SERVICE BULLETIN

Service Bulletin No. 475C
(Supersedes Service Bulletin No. 475B)
Engineering Aspects are
FAA Approved

SUBJECT: Crankshaft Gear Modification and Assembly Procedures

MODELS AFFECTED: All Lycoming direct drive piston aircraft engines (including VO-360 and IVO-360; excepting O-320-H, O-360-E, LO-360-E, TO-360-E, LTO-360-E, and TIO-541 series engines).

Figure 1. Details for Repairing Pilot Diameter of Crankshaft

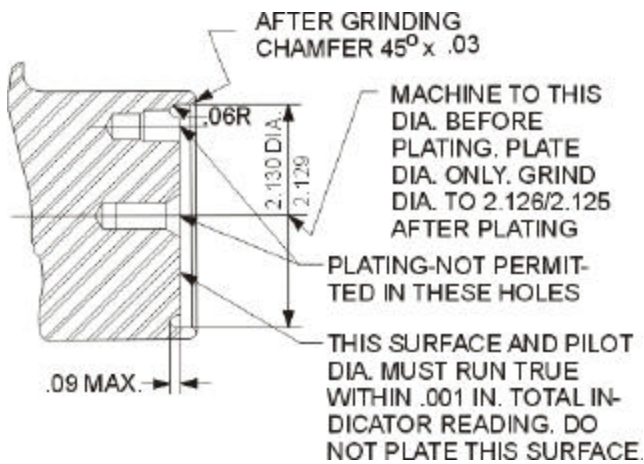
3. Check the pilot diameter of the counterbore on the end of the crankshaft for size and evidence of damage. This diameter should not exceed 2.1262 inches when measured at any location. If found to be oversize, the crankshaft may be repaired as described in the following steps. Do not attempt to reuse a crankshaft with an oversize pilot diameter.

- a. After removing the dowel, machine the pilot diameter in the end of the crankshaft to 2.129/2.130 inch as shown in the illustration. See Figure 1. Also, cut the .09 deep x .06R undercut as shown.

- c. After plating, stress relieve the shaft by baking at 390° to 410°F for 3 to 5 hours.
 - d. Grind the plated pilot diameter surface to 2.125/2.126 inch. Note that the diameter must run true with rear main journal within .001 inch total indicator reading.

- e. Chamfer edge of pilot diameter $45^\circ \times .03$ as shown in Figure 1.
4. If the dowel has been removed, check the condition of the dowel hole in the crankshaft. If out of round or oversize, ream as required for installation of an oversize dowel. Available oversize dowels and the corresponding size for reamed holes are shown in Table 1.
5. Install a new dowel in the crankshaft as shown in Figures 2 and 3. Insure that the correct dowel is installed.

Figure 2. Section Thru End of Crankshaft Showing Driven Height of STD-1065 Dowel

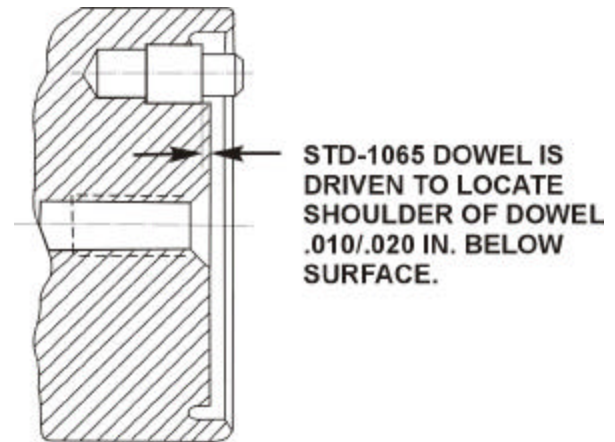
2. Check the condition of the dowel in the end of the crankshaft. It should be perfectly smooth with no indication of nicks or deformation. If it is out of round, it should be removed and replaced with a new one. Replacement instructions are in paragraph 4. If dowel condition is acceptable, insure that it is installed as shown in Figure 2 or 3.

Figure 5. Details for Rework of Crankshaft Gears to Current Configuration

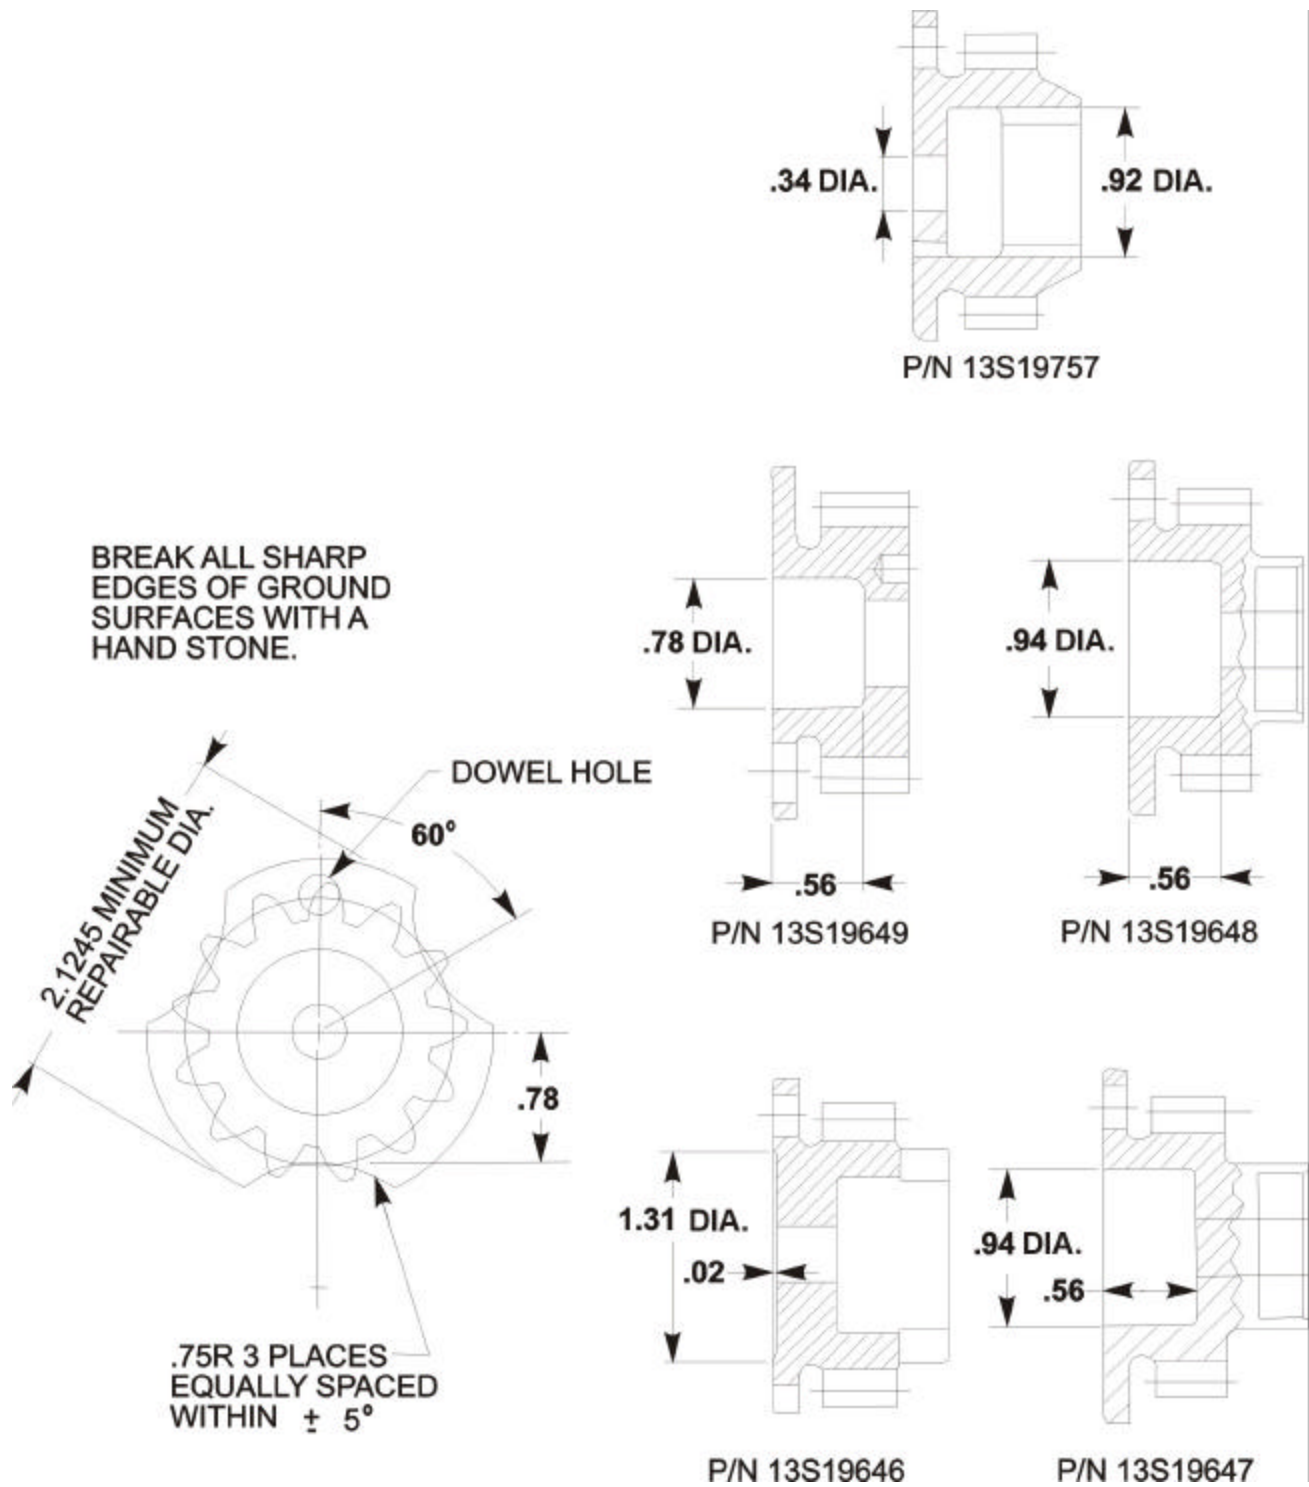
CRANKSHAFT GEARS FOR APPLICABLE ENGINES ARE NOW MANUFACTURED WITH THREE 3/4 INCH RADIUS SCALLOPS CUT INTO THE O.D. OF THE PILOT FLANGE AND A COUNTERBORE ON THE BACK SIDE OF THE GEAR. THESE ENLARGED SCALLOPS HAVE BEEN ADDED TO ALLOW INSPECTION OF THE GEAR AND CRANKSHAFT ASSEMBLY. SERVICEABLE GEARS MUST BE MODIFIED AS SHOWN IN FIGURE 5. PRIOR TO BEING REASSEMBLED ON THE CRANKSHAFT, OR A NEW GEAR THAT HAS BEEN MANUFACTURED TO THIS CONFIGURATION MUST BE INSTALLED. BEFORE MODIFYING THE GEAR, MEASURE THE DIAMETER OF THE PILOT FLANGE. IF IT IS LESS THAN 2.1245 INCH, IT SHOULD NOT BE RESUED. THE ORIGINAL 2.1250/2.1255 DIMENSION OF THE CRANKSHAFT GEAR MUST BE RESTORED WITH A FLASH COPPER PLATE OF UP TO .0005 INCH MAX.

NOTE: Revision “C” revises Table 2 and Figure 5.

Figure 6. Rear End View of Crankshaft Showing Associated Parts

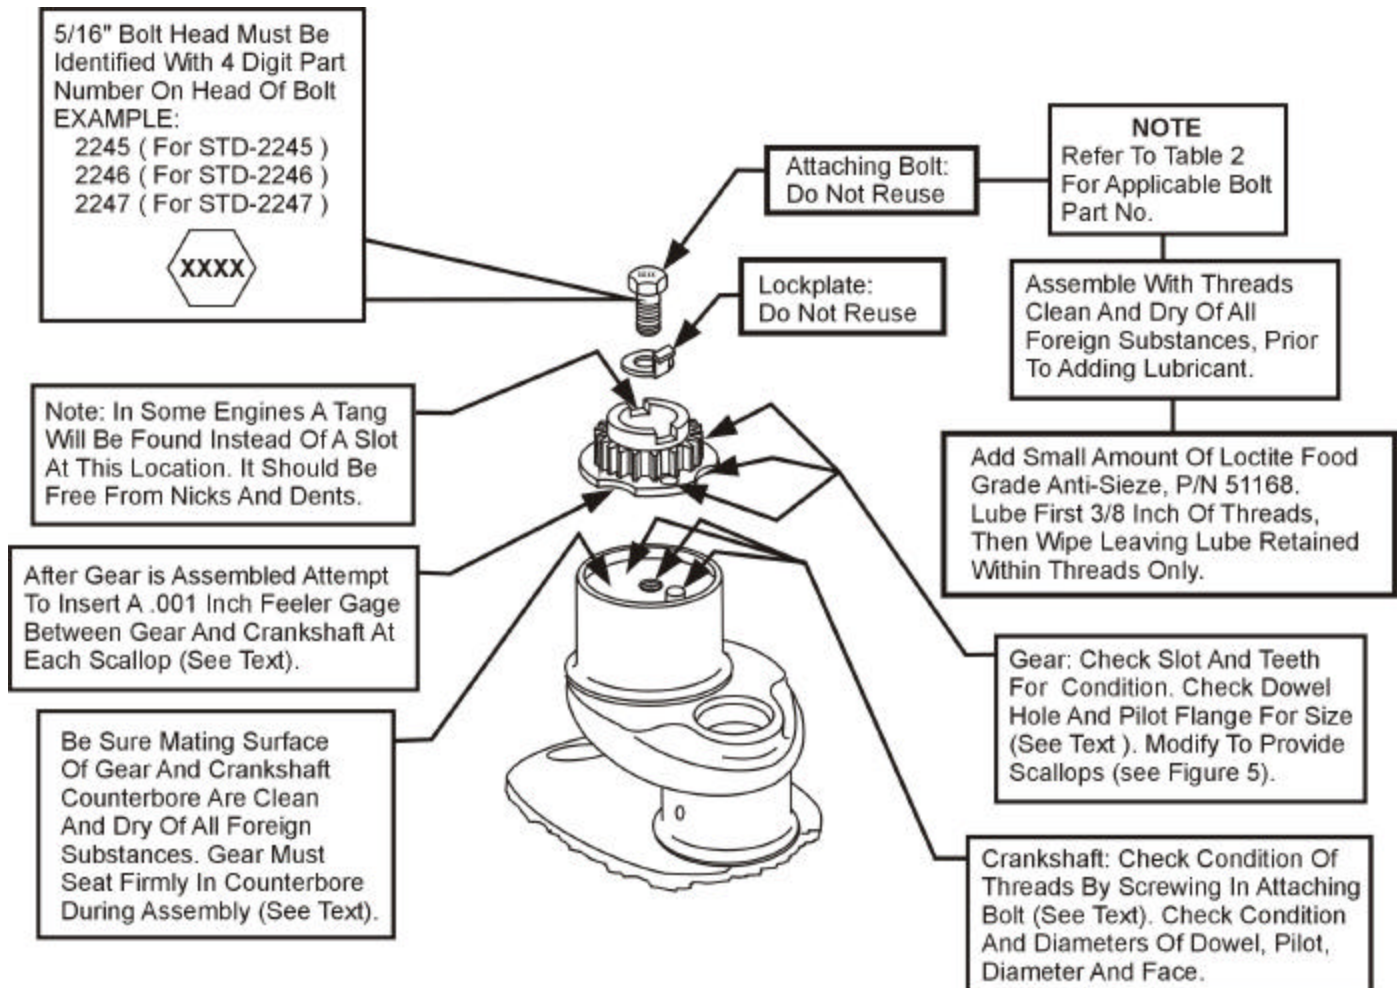
6. Assemble the gear to the crankshaft **using both a new lockplate and bolt**. Refer to Figure 6. The correct bolt, lockplate and dowel for each gear are shown in Table 2. Tighten the bolt to 125 in.-lbs. torque, then with a hammer and brass drift, tap lightly around the pilot flange of the gear and listen for sharp solid sounds from the hammer blows that would indicate that the gear is seated against the crankshaft. As a check on the seating against the crankshaft, attempt to insert a pointed .001 inch thick feeler gage or shim stock between the gear and crankshaft at each of the three scallops. The .001 feeler gage, or any smaller feeler gage, must **NOT** fit between the two surfaces at any location. (.001 feeler gage is used as an indicator, however, there must be no clearance between crankshaft and gear.) Retighten the gear attaching bolt to the proper torque. Tighten the 5/16 inch bolt to 204 in.-lbs. torque or the 1/2 inch bolt to 660 in.-lbs. torque. Measure the clearance between the O.D. of the gear flange and the pilot I.D. of the crankshaft. There should not be more than .0005 inch clearance at any point.

Figure 7. Minimum Dimension of Crankshaft

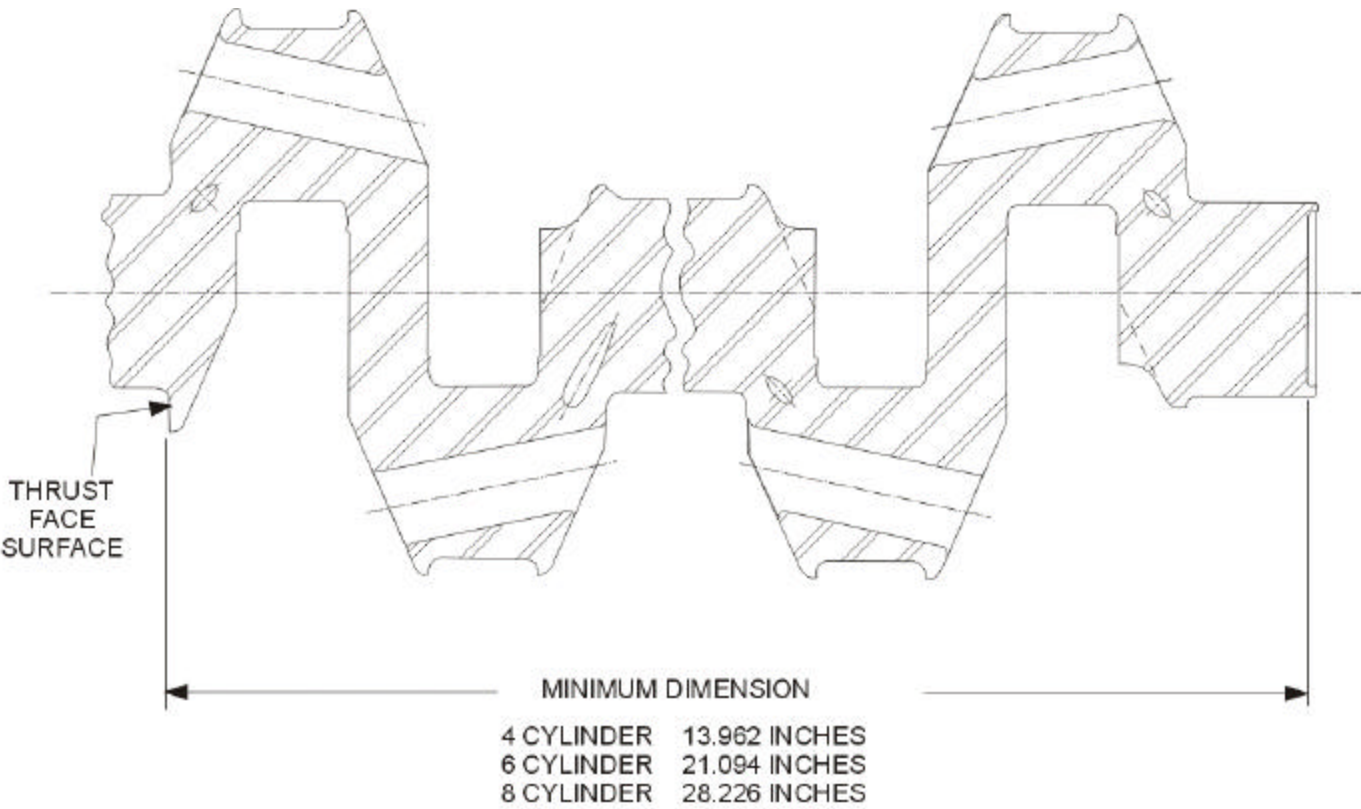
THE CRANKSHAFT COUNTERBORED GEAR MOUNTING FACE SHOULD BE CHECKED FOR DAMAGE. IF THE SURFACE REQUIRES REPAIR OTHER THAN SPECIFIED IN “CAUTION” ON PAGE 1, THE CRANKSHAFT SHOULD FIRST BE MEASURED AS SHOWN IN FIGURE 7. IF THE CRANKSHAFT MEASURES MORE THAN THE MINIMUM DIMENSION SHOWN IN FIGURE 7, THE SURFACE MAY BE REWORKED DOWN TO THE DIMENSIONS SHOWN. (DO NOT PLATE THIS SURFACE.) THE SURFACE MUST BE TRUE WITHIN .001 IN. TOTAL INDICATOR READING TO REAR MAIN BEARING AND THE SURFACE FINISH MUST BE HELD TO 45 TO 90 MICROINCHES.

INSURE MINIMUM DIMENSION IS MEASURED BETWEEN THRUST FACE SURFACE AND PILOT.
